**SUBJECT: DIABLO CANYON POWER PLANT, UNITS 1 AND 2 - ISSUANCE OF AMENDMENTS RE: REVISION OF REACTOR COOLANT SYSTEM (RCS) MINIMUM FLOW SPECIFIED IN TECHNICAL SPECIFICATION 3.4.1, "RCS PRESSURE, TEMPERATURE, AND FLOW DEPARTURE FROM NUCLEATE BOILING (DNB) LIMITS" (CAC NOS. MF6731 AND 6732)**

Amendment No. 226  
License No. DPR-80

Amendment No. 228  
License No. DPR-82

SAFETY EVALUATION BY THE OFFICE OF NUCLEAR REACTOR REGULATION  
RELATED TO AMENDMENT NO. 226 TO FACILITY OPERATING LICENSE NO. DPR-80  
AND AMENDMENT NO. 228 TO FACILITY OPERATING LICENSE NO. DPR-82  
PACIFIC GAS AND ELECTRIC COMPANY  
DIABLO CANYON POWER PLANT, UNITS 1 AND 2  
DOCKET NOS. 50-275 AND 50-323

Figure 2.1.1-1  
REACTOR CORE SAFETY LIMIT

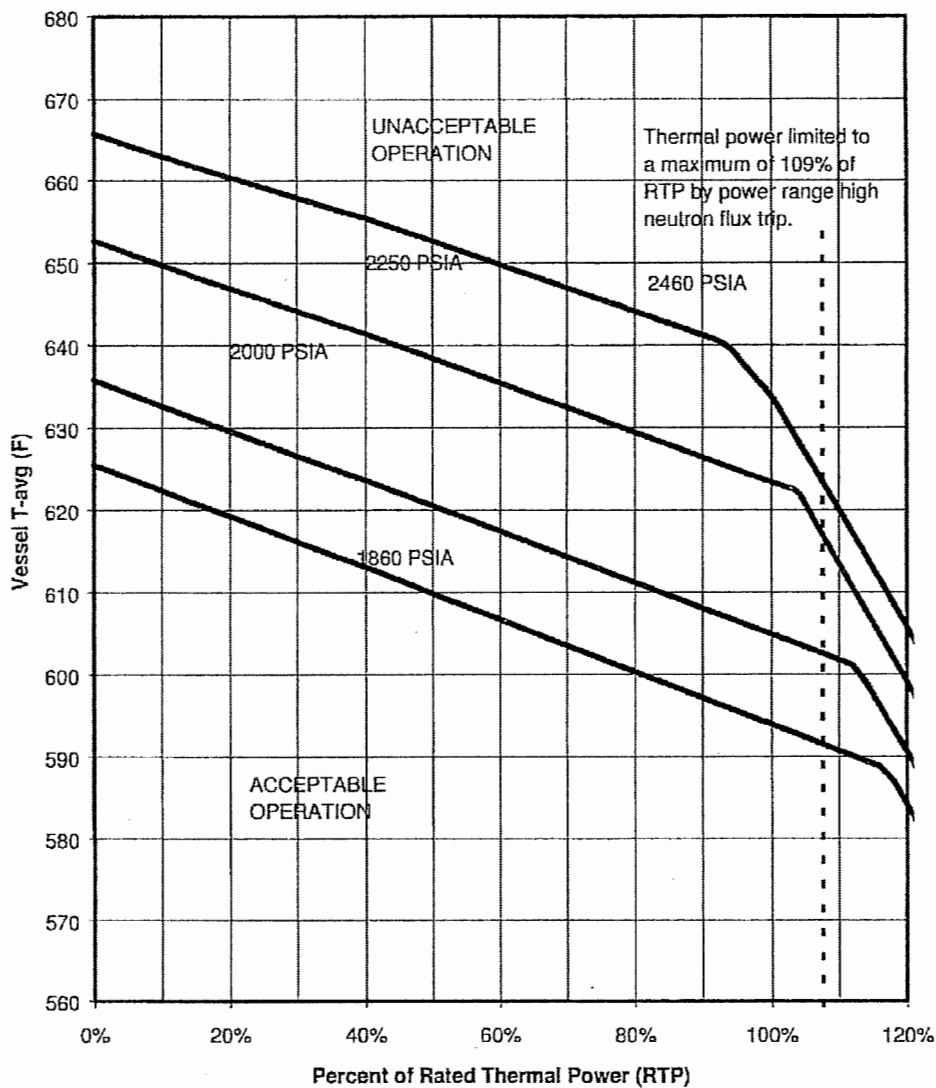
Current Figure 2.1.1-1 has the following footnote:

When operating in the reduced RTP [rated thermal power] region of Technical Specification LCO 3.4.1 (Table 3.4.1-1 for Unit 1 and Table 3.4.1-2 for Unit 2) the restricted power level must be considered 100% for this Figure.

The footnote makes a reference to Tables 3.4.1-1 and 3.4.1-2, which are being deleted. Hence, the footnote is no longer applicable and is being deleted.

The licensee is proposing the removal of TS Tables 3.4.1-1 and 3.4.1-2, as well as a footnote in Figure 2.1.1-1 that references the aforementioned tables. The licensee explained that the tables were previously needed to implement a less-restrictive minimum RCS flow value at powers between 90 percent and 100 percent. This was due to deficiencies in the calorimetric method by which the licensee was determining the RCS flow under some conditions. The licensee indicated that DCP, Units 1 and 2, now solely relies on the elbow tap method to determine RCS flow, so the relaxed RCS minimum flow limits at lower powers are no longer necessary. The footnote in Figure 2.1.1-1 clarified that when operating in the power-flow region defined by Tables 3.4.1-1 and 3.4.1-2, then for purposes of determining the acceptable operating vessel T-avg for a given pressure based on this figure, the power level must be assumed to be at 100 percent. Since this power-flow region will no longer be available for use by DCP, Units 1 and 2, this footnote no longer applies.

The removal of Tables 3.4.1-1 and 3.4.1-2 is more conservative because it removes the option of relaxing the minimum RCS flow at powers between 90 percent and 100 percent. Therefore, the NRC staff concludes the proposed deletions to be acceptable.

The NRC staff concludes that based on appropriate implementation of NRC guidance on relocation of RCS flow DNB limits to the COLR and the conservatism of the changes, the licensee's proposed changes to the DCP, Units 1 and 2, TS 3.4.1 (LCO 3.4.1.c, SRs 3.4.1-3 and 3.4.1-4, Tables 3.4.1-1 and 3.4.1-2, and Figure 2.1.1-1) are acceptable.
